Technical Service Information

2000 & LATER DODGE TRUCKS & VANS

46RE INTERNAL LINKAGE AND SAFETY NEUTRAL SWITCH CHANGES

Figure 1

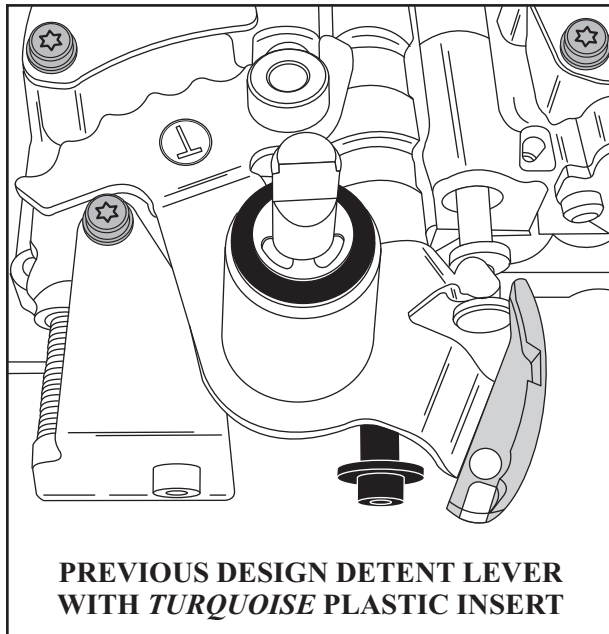
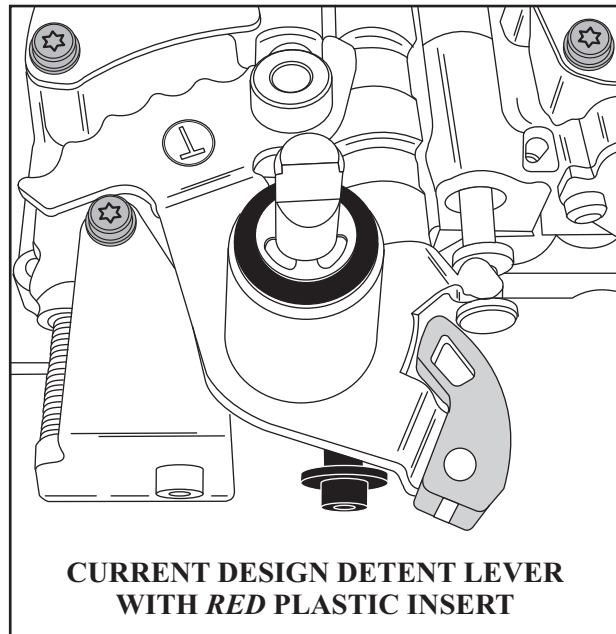
CAUSE: The safety neutral switch and the valve body detent lever changed for the 2000 model year. The switch is longer and the detent lever dimensionally changed to accommodate the new switch. Figures 1 and 2 show the dimensional differences between the previous and current design detent levers. Figures 3 and 4 illustrate the correct and incorrect assembly using the short switch. Figure 5 shows the correct assembly using the long switch.

CORRECTION: The detent lever with the *turquoise* plastic insert goes with the *short* safety neutral switch. The detent lever with the *red* plastic insert goes with the *long* safety neutral switch.
